Planning Report

City of Verona

The Woods at Cathedral Point

General Development Plan, Final Plat, & Zoning Map Amendment

Figure 4 - Final Plat

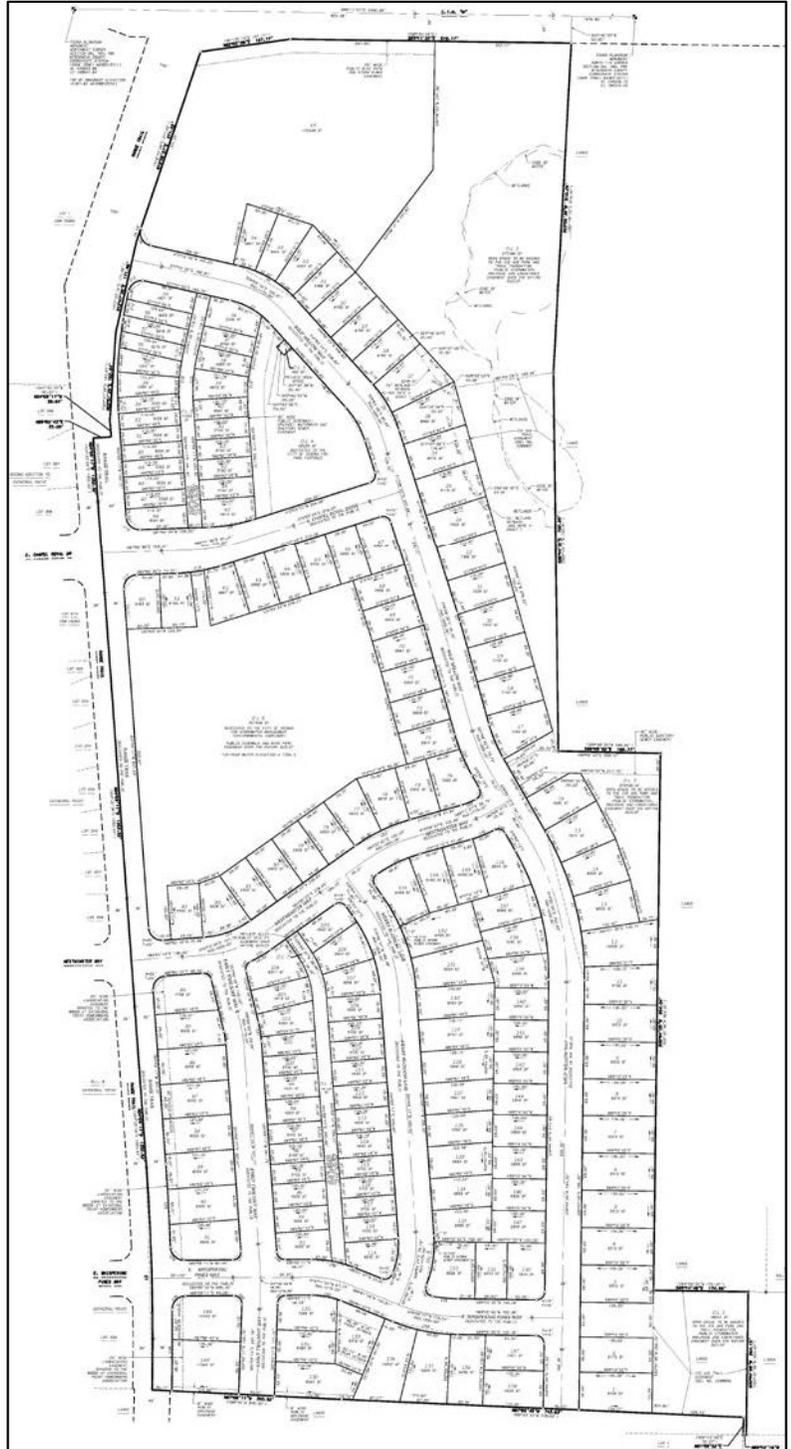
For the single-family lots in the NR zone, the smallest lot size will be 3,700 square feet while the largest lot will be 11,965 square feet. The smallest outlot will be 400 square feet for the cluster mailboxes and the largest at 273,766 square feet (6.3 acres). The proposed lots do not conform to the minimum lot size and dimensional standards of the NR zoning district. The minimum dimensional standard for the NR zoning district is 8,000 square feet and 10,000 square feet for a corner lot. The Applicant is requesting an exemption to the minimum lot standard, which is discussed in the section below.

Figure 6 - Open space and Trail map with Trail easements shown in red

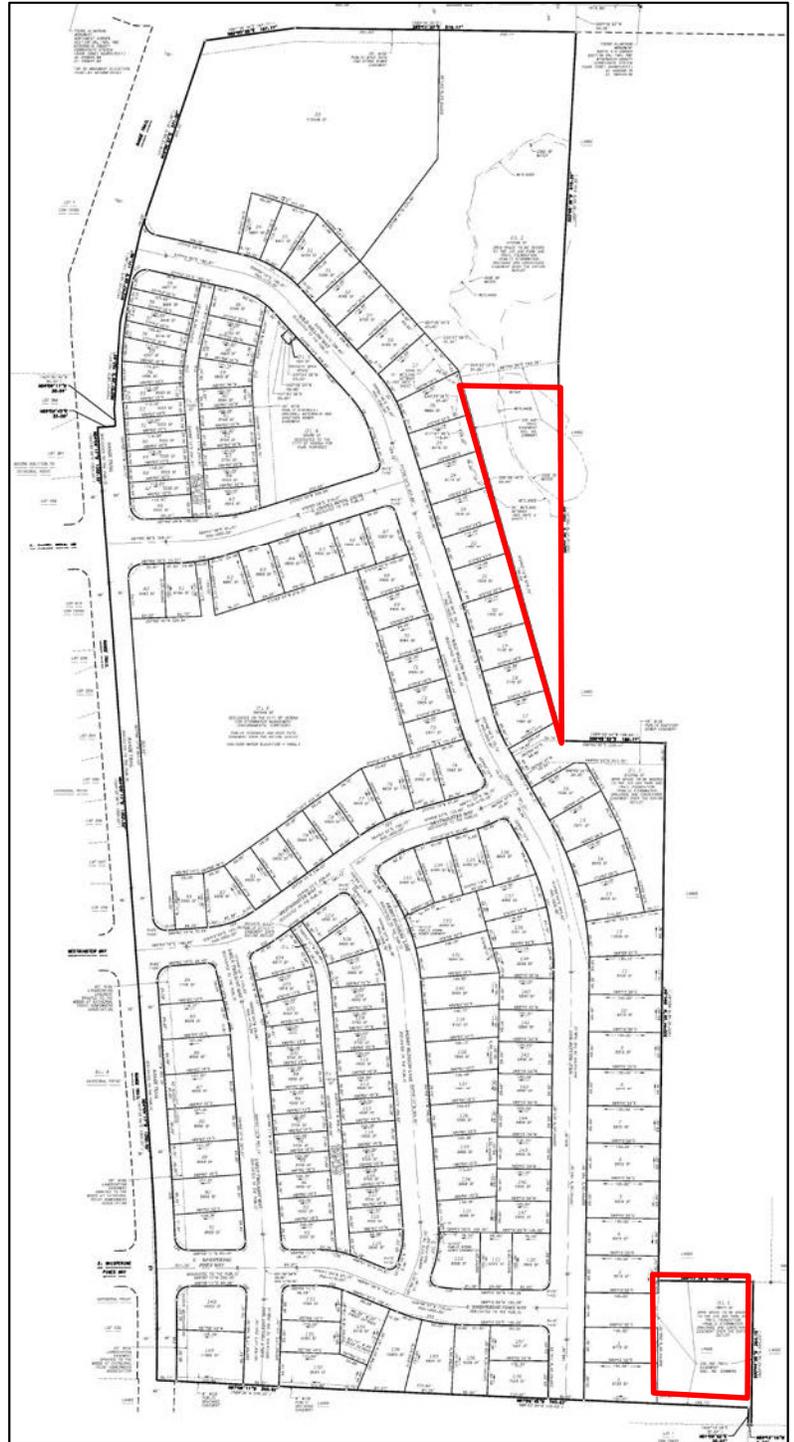
The Park, Recreation, and Forestry Commission reviewed the plans at their meeting in September 2019 and in January 2020. Comments from the September meeting included confirmation that the proposed land dedication totaled 9.6 acres which was slightly more than the 9.4 acres required by ordinance, liked the focus on the Trail and overall layout of the plan, and raised concerns about access to the oak conservancy area. No formal action was taken at the September meeting. Comments from the January meeting included wanting access points to OL 6 shifted by a couple of lots to gain better access to the open space, could an additional access point be located between lots 68 and 73, concerns about tree

preservation and grades, and whether full parkland credit should be given if access does not improve to OL 6. The Commission voted that the Applicant would only receive 50% credit toward satisfying the requirements of the plat for OL 6 due to lack of direct access and would be utilized by only the homeowners.

The Applicant has modified the final plat since the January 2020 meeting. One (1) modification is that the final plat states, "Open space to be deeded to the Ice Age Park and Trail Foundation" for outlots 1 and 2. There are 7.39-acres for the Trail as shown on the final plat. A second modification is that Lot 83 located on the corner of Range Trail and Westminster Way was shifted away from the corner to the east to fill in the access point to OL 6 depicted in Figure 7. Although the Park Board recommended modifications to lots to have better access to interior parkland, the Applicant determined it was not in their best interest to make these modifications due to significant grading and slope (15% slope) concerns. However, the Applicant did explore these ideas and tried to redesign these lots to accommodate better access to parkland, which did not work in the end. The Applicant understands that they are deficient in their parkland dedication and understand that a payment is required.
